Town of Parker Community Development Department
Development Review Division
Attention: Stacey Nerger

Application Type: **Site Plan – Non-Residential**
Status: **First Referral**
Application Name: Douglas 234 F6 AMD 2 L8A - Les Schwab Tire
Case/AP#: **SP23-054**
Referral Received: July 28, 2022
Comments Due: August 18 ,2022

Review date: **August 7, 2022**
Plan reviewer: **Randall L. Capra, rcapra@parkeronline.org**
Phone: 303.805.3163

Narrative: The applicant, Cushing Terrell, is proposing a 10,037 Sq. Ft. tire store and service center. The site is located on the northeast corner of Hess Road and Chambers Road.

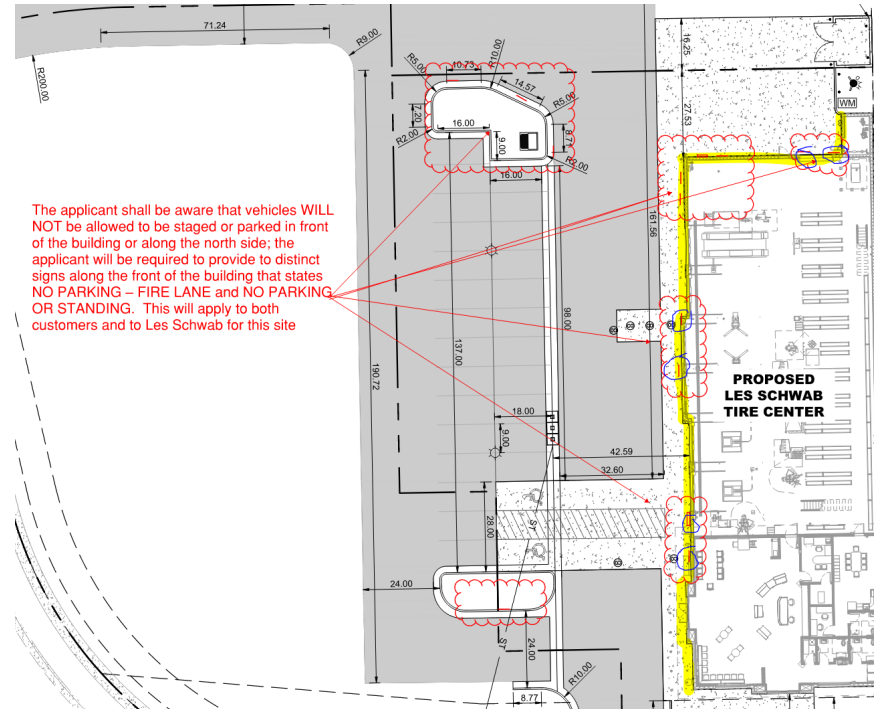
6. The applicant shall provide an additional NO PARKING – FIRE LANE signage in the location shown below; this location is on the south side of the access road just south of the building. See item #5 above specific to this issue.

Note - The Town of Parker requires that fire apparatus access roads meet the clear-width and weight-bearing standards of the jurisdiction in which the project is located. Roadways shall be designed to support the imposed weight of fire apparatus, 30-ton, two axle and 40-ton, three axle vehicles. **An unimpeded clear width of 26-feet shall be maintained at all times.** As such, any location where parked vehicles would obstruct this clear width

requirement will require "NO PARKING – FIRE LANE" signage. *This signage shall be red on white. Update design criteria has been provided at the end of this document; ensure compliance when resubmitting.*
Not satisfied with the second submittal; issues were not addressed.
